Service Bulletin

June 18, 2007

SEB07-2
Revision 2**TITLE****ENGINE MOUNT BRACKET INSPECTION****EFFECTIVITY**

Figure 1. Engine Mount Bracket Inspection (Sheet 1)

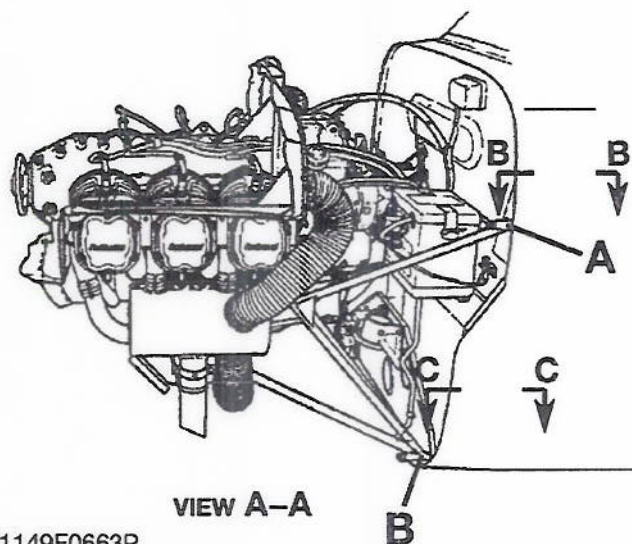
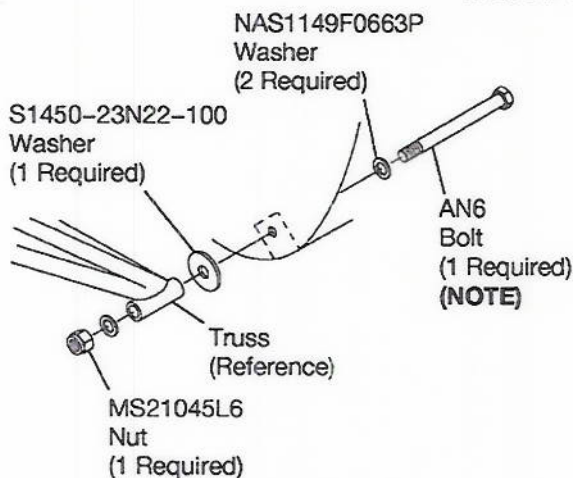
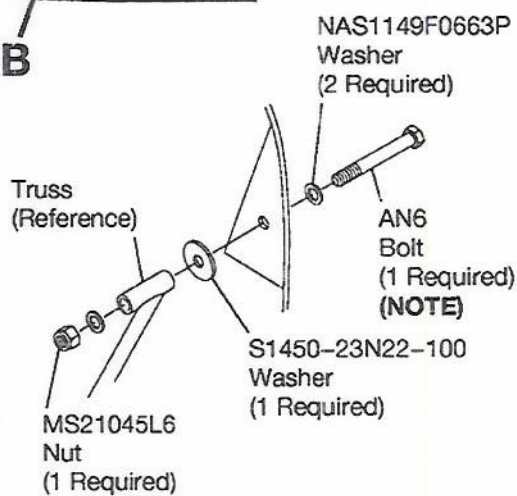
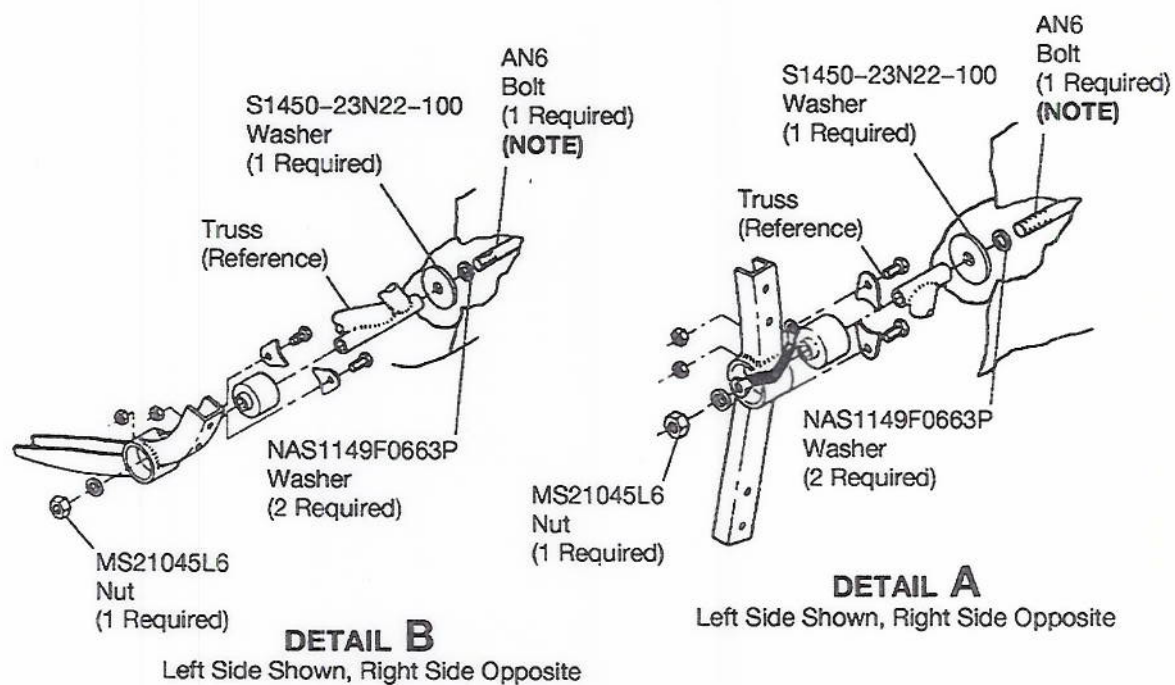
5. Do an inspection of the left 0513132-11 Upper Mounting Bracket:
 - A. (Refer to Figure 1, View A-A and Detail A.) From a position under the instrument panel, move the wires and the insulation away from the bolt that attaches the upper left engine truss to the left 0513132-11 Upper Mounting Bracket.

- D. (Refer to Figure 1, View D-D.) Look carefully for a deformed or cracked left 0513132-11 Upper Mounting Bracket.
 - (1) If you do find deformities or cracks, go to Step 5E.

- (2) If you do not find deformities or cracks, go to Step 6.
- E. (Refer to Figure 1, View B-B.) Remove the left 0513132-11 Upper Mounting Bracket from the 0513132-7 Upper Left Stringer and the airplane skin.

- (9) Apply Alodine to bare metal.
 - (10) Do a touch-up of the paint as necessary.
 - (11) (Refer to Figure 1, Detail A.) With the AN6 Bolt, S1450-23N22-100 Washer, two NAS1149F0663P Washers, and MS21045L6 Nut, attach the upper left engine truss to the left 0513132-11 Upper Mounting Bracket.

- A. (Refer to Figure 1, Detail A and Detail B.) From a position under the instrument panel, move the wires and the insulation away from the bolts that attach the upper left and the upper right engine truss to the upper mounting brackets.

- (12) Torque the MS21045L6 Nut to 160 to 190 inch-pounds.
 - (13) Go to Step 6.

- C. Remove and discard the upper left AN6 Bolt and MS21045L6 Nut that attach the engine truss to the mounting bracket, and install a new AN6 Bolt and MS21045L6 Nut. Torque the MS21045L6 Nut to 160 to 190 inch-pounds.

- E. Remove and discard the lower left and lower right AN6 Bolts and MS21045L6 Nuts that attach the engine truss to the mounting brackets, and install new AN6 Bolts and MS21045L6 Nuts. Torque the MS21045L6 Nuts to 160 to 190 inch-pounds.

Figure 1. Engine Mount Bracket Inspection (Sheet 2)

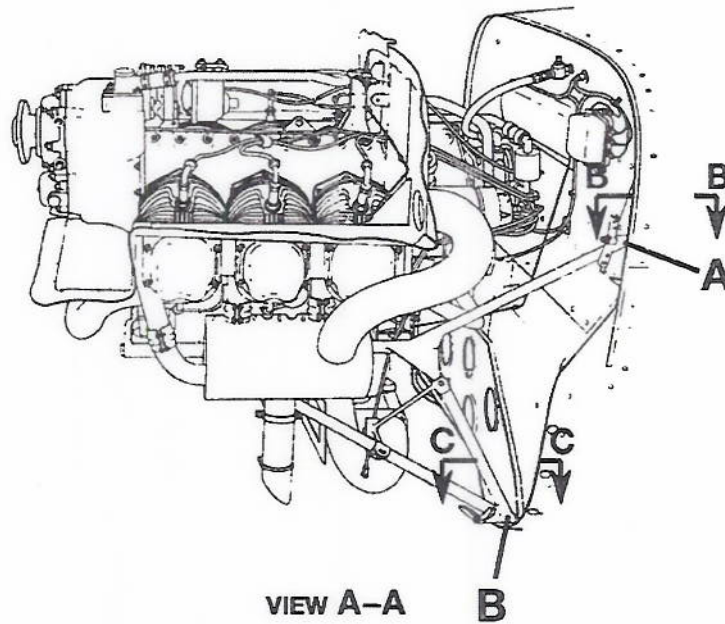
- B. (Refer to all applicable details and views in Figure 1.) Do Steps 5B thru 5F again for the 0513132-10 Lower Right Mounting Bracket and the 0514132-9 Lower Left Mounting Bracket as necessary. Go to Step 9.
